Title: 2010 Emissions Pre-DOC Mounting clamp

Applies To: 2010 Emissions 11L and 13L Engines

PDOC Clamp breakage

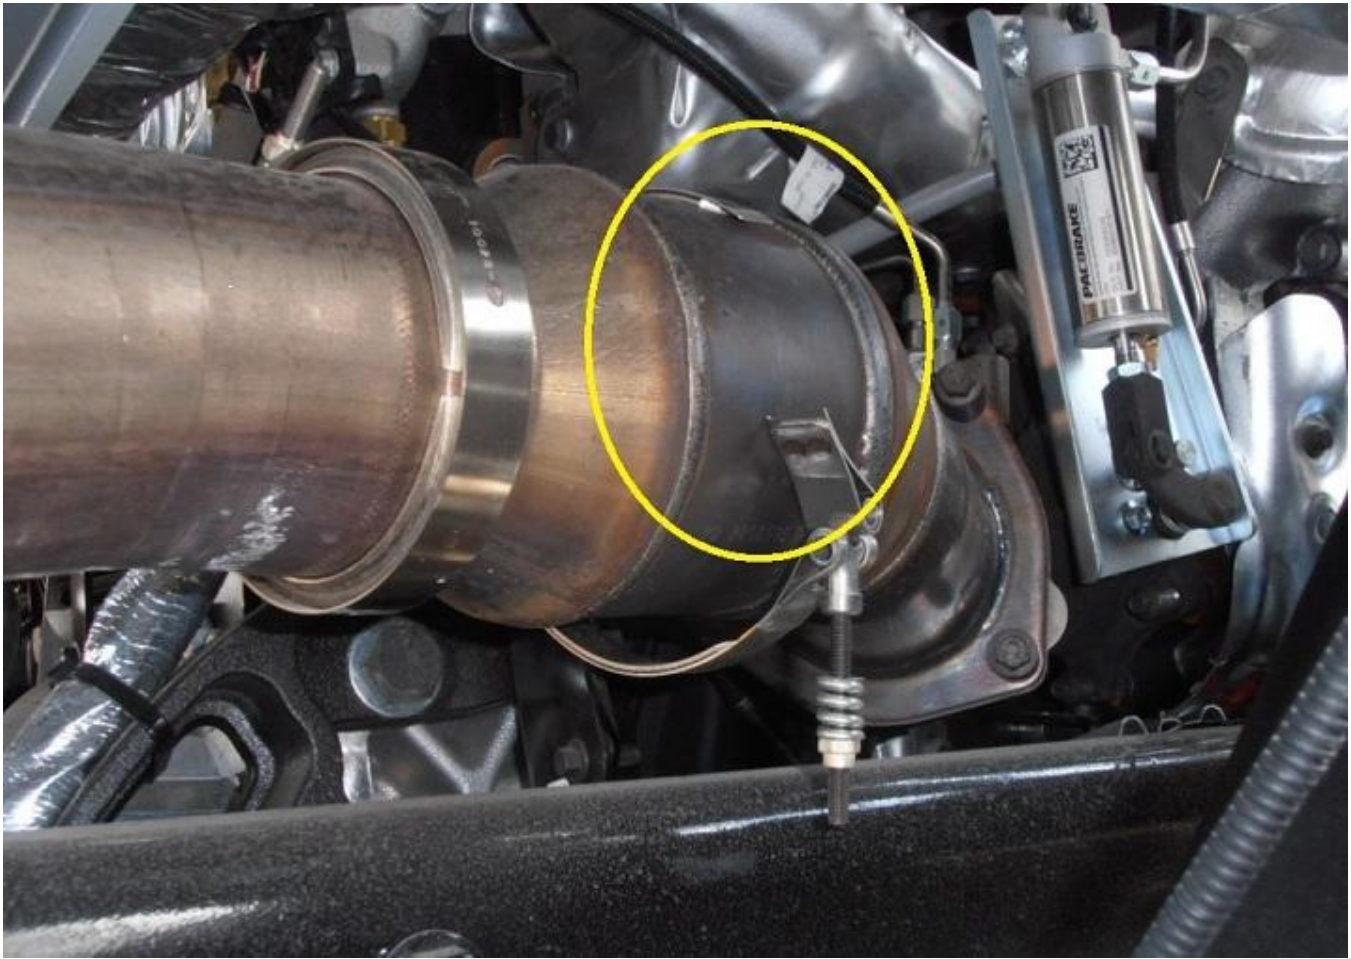
The mounting clamp for the Pre-DOC has been modified to be more robust and resist breakage. Units with failed mounting clamps should be upgraded to a new V-Band clamp which will need a new wide bracket to allow for the clamp to be secured. In the case that the unit has a new style V-Band clamp that fails and already has the upgraded wider bracket, simply replace the V-Band clamp.

- When broken or missing clamp is discovered, install the V-Band type clamp listed in the Part Information Section
- New Style Clamp pictured

- **Install new clamp in place so that the V-Clamp bolt head is facing the 2 o'clock position when viewed from rear of truck**

- Torque Clamp to 3 Nm / 26-27 in. lbs.
- Torque PDOC clamp bracket bolts to standard torque
